Model: Russian-C1		Date: 15-Feb-00	No.: RA265002
Subject: Service Manual Correciton		Prepared by: S. Tomoe	
From: Technical Services Dept., GTS Division			
Classification:	<input type="checkbox"/> Troubleshooting	<input type="checkbox"/> Part information	<input type="checkbox"/> Action required
	<input type="checkbox"/> Mechanical	<input type="checkbox"/> Electrical	<input type="checkbox"/> Service manual revision
	<input type="checkbox"/> Paper path	<input type="checkbox"/> Transmit/receive	<input type="checkbox"/> Retrofit information
	<input checked="" type="checkbox"/> Other ()

Please correct your service manuals as follows:

3.12. 1,000-SHEET FINISHER INSTALLATION (P 3-35)

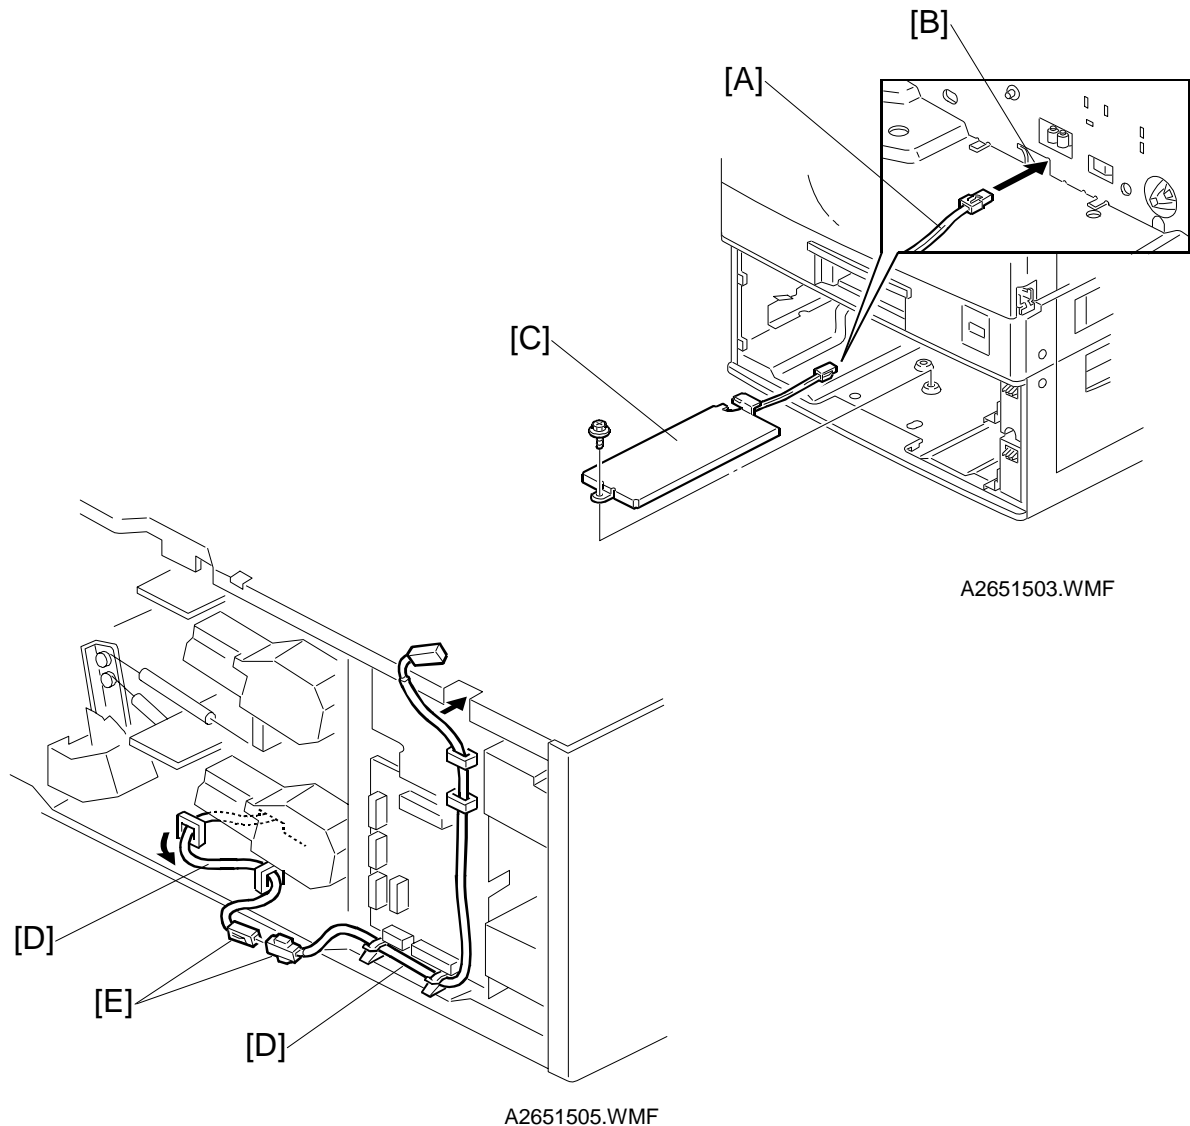
Delete Note no.2: "If this finisher will be installed on the A265 or A267 copier, ..."
